Concept Report Form

Project Name	SR 138 – Bridge over Overflow (OF) and Bridge over Branch (Brch)									
PIN	134865.00 and 134866.00									
Route Information	Route	NHS (Y/N)	Functional Class			City		County		
	SR138	No	Rural Major Collector					Madison		
Project Information	Begin Log Mile	End Log Mile	AADT¹	Design Hour Vol. (DHV)¹	Truck %¹	Design Speed (MPH)	Posted Speed (MPH)	Base Year	Design Year

Project: SR-138, Bridge over Overflow, LM 4.88 & Bridge over Branch, LM 4.95 (TMA)
Comment Resolution Form
County: Madison
PIN 134865.00 & 134866.00

REALIGN OPTION

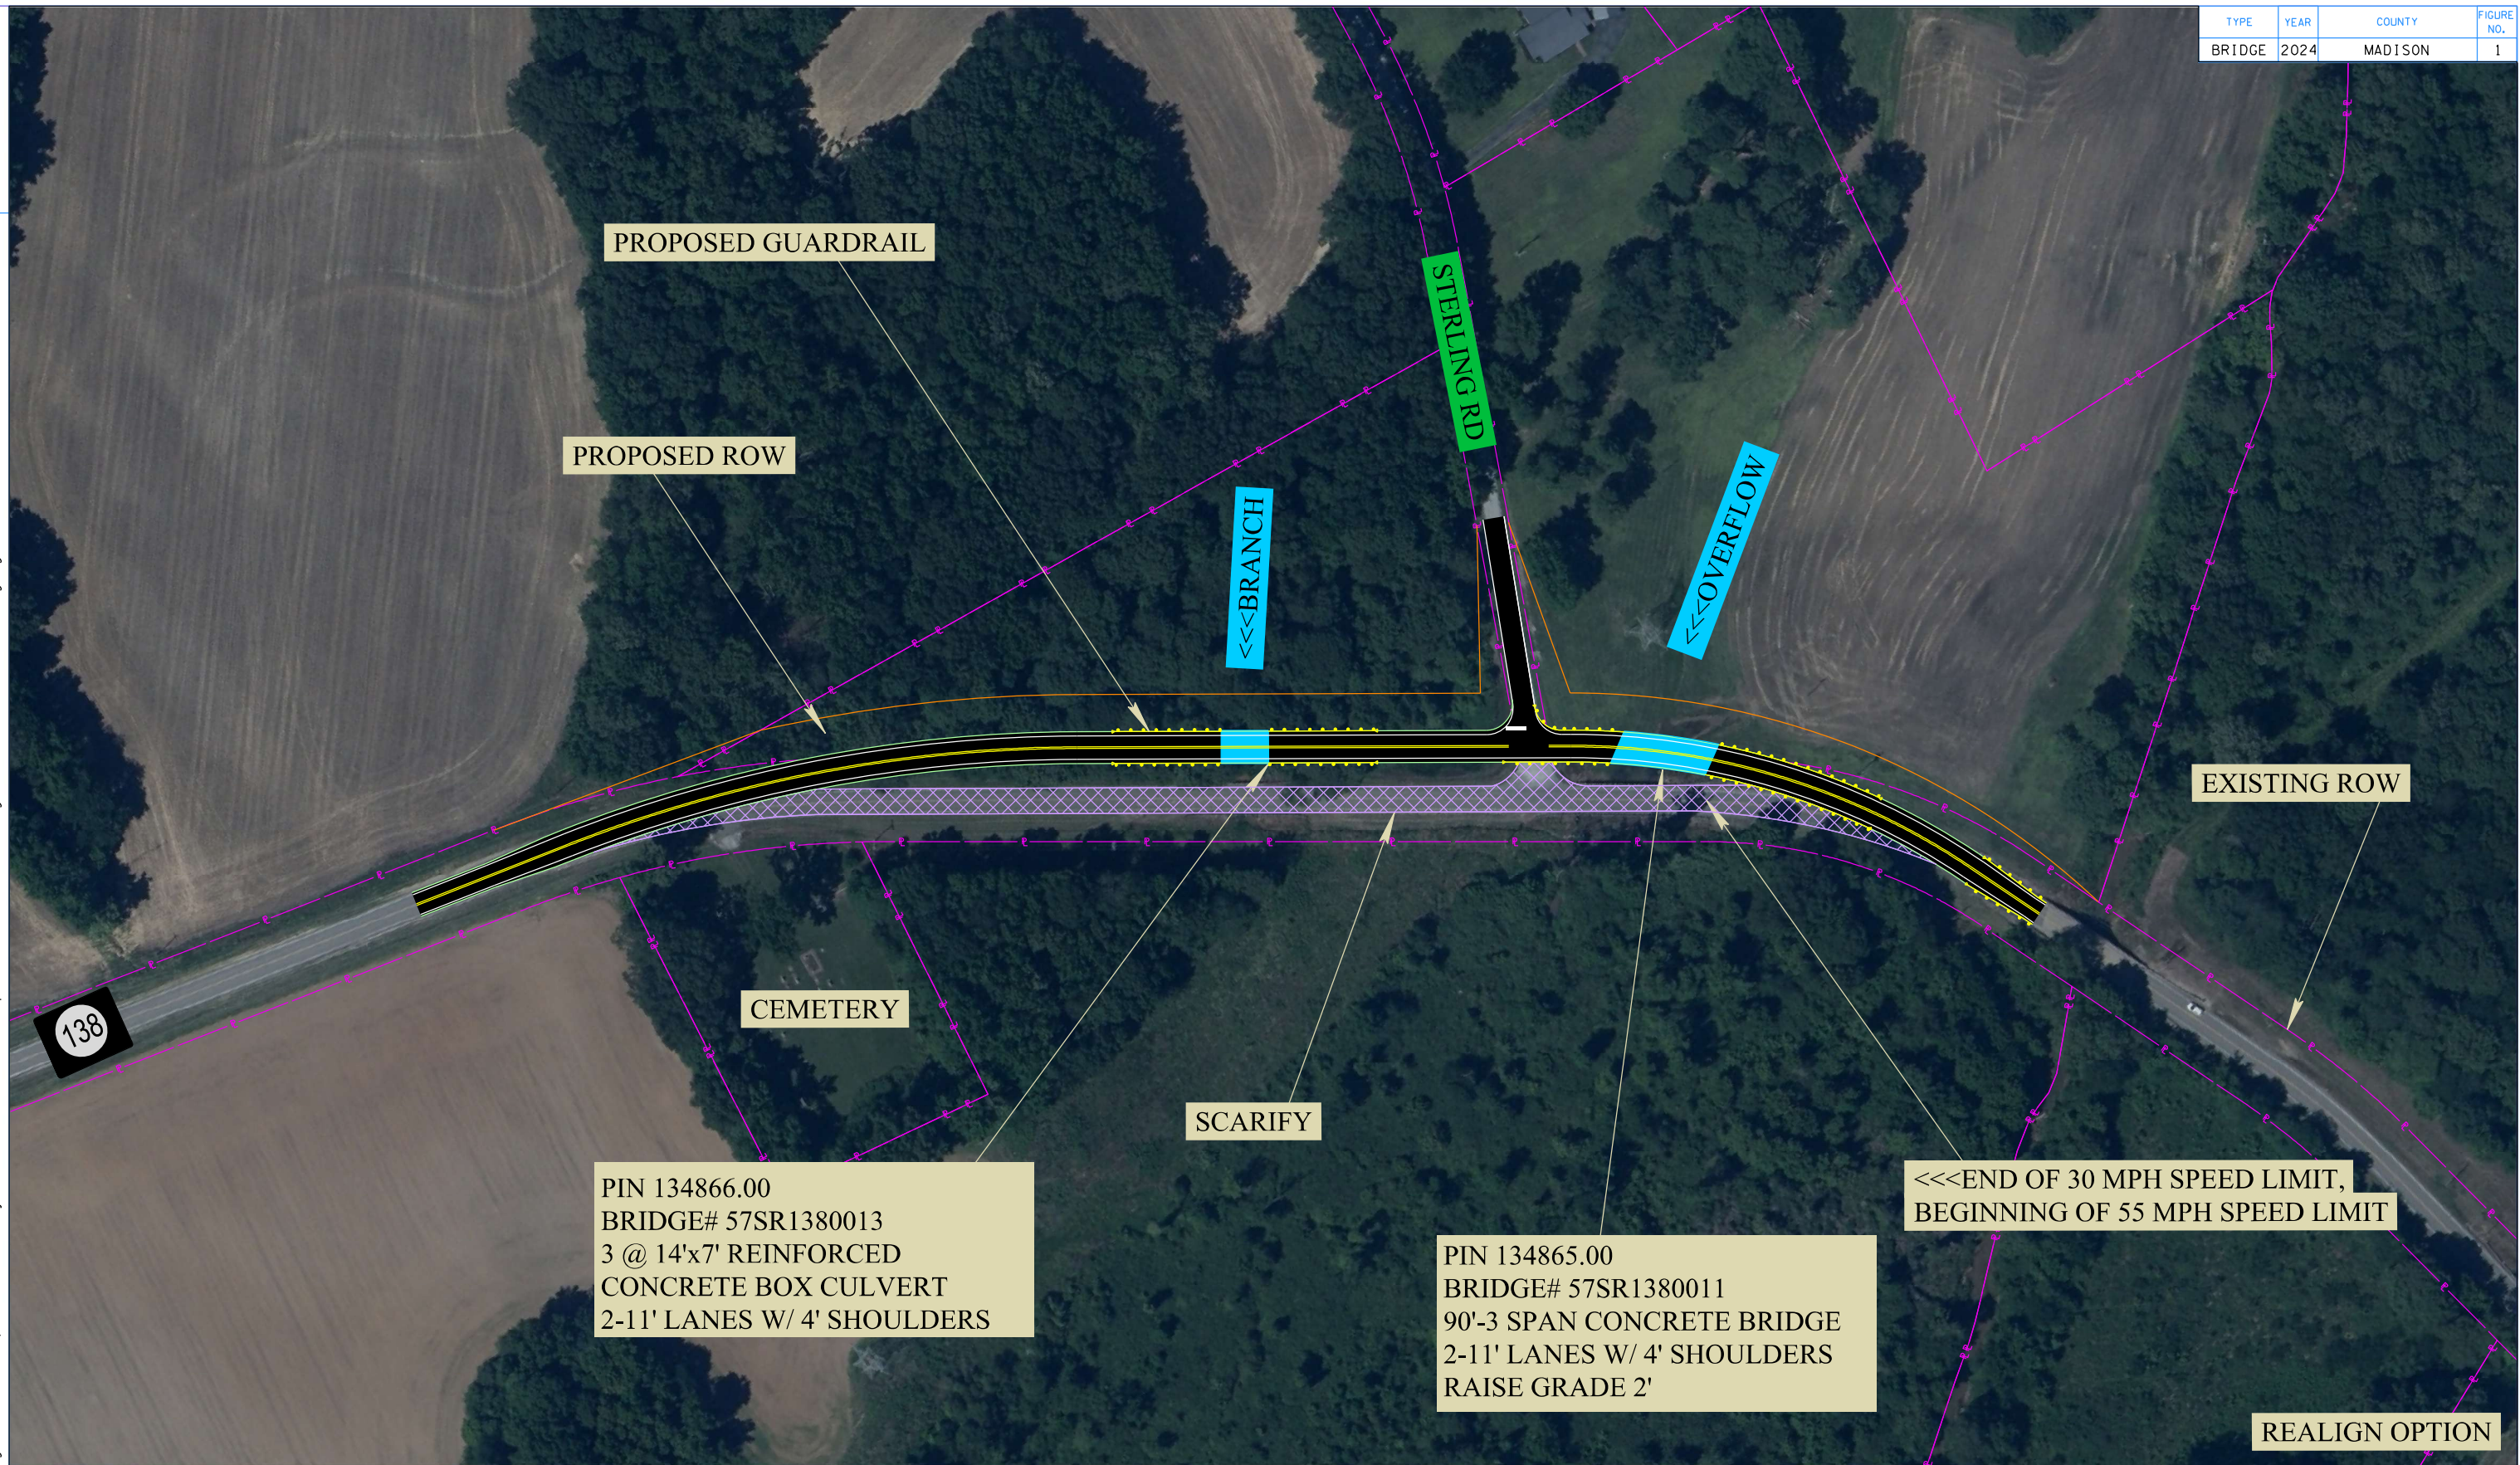
Comment Stage	Division	Commenter	Date	Comment	Comment Addressed?	Additional Notes
Draft Report Review (OSD2)	Design	Samuel Reed	5/14/2024	If the realignment is attempted, detouring the state route may not be necessary. The bulk of the project can be completed and then connected afterward to the state route.	Yes	Noted. Two Options are provided for the PDN team to help advise with decision making.
Draft Report Review (OSD2)	Design	Samuel Reed	5/14/2024	In both cases, additional rights-of-way for the environment should be considered. Raising the grade will result in wetland impact.	Yes	Noted, widened ROW.
Draft Report Review (OSD2)	Design	Samuel Reed	5/14/2024	Raising the grade may result in conflict with the box bridge. In the case of realignment, the horizontal curve is extended to include the bridge. This will likely result in a superelevation of the structure. Structures does not prefer bridges with superelevation.	Yes	Noted. Coordination with Structures during design to determine the feasibility of the curved structure will need to be explored. Structures has asked STID in the past to keep super transitions off proposed bridges. Realignment of bridge at L.M. 4.88 is also constrained due to the location of the bridge at L.M. 4.79.

Draft Report Review (OSD2)	Design	Samuel Reed	5/14/2024	Raising the grade may result in conflict with the box bridge.	Yes	Noted. More clarifications on the conflict may be needed for further assessment during design.
Draft Report Review (OSD2)	Design	Samuel Reed	5/14/2024	Ensure the project end limit leaves sufficient space to taper out of the horizontal curve.	Yes	Extended the approach a little further on the western side to account for the super transitions.
Draft Report Review (OSD2)	Design	Samuel Reed	5/14/2024	Additional Guardral may need to be considered for the horizontal curve leading into the bridge.	Yes	Noted, extended guardrail on drawing.
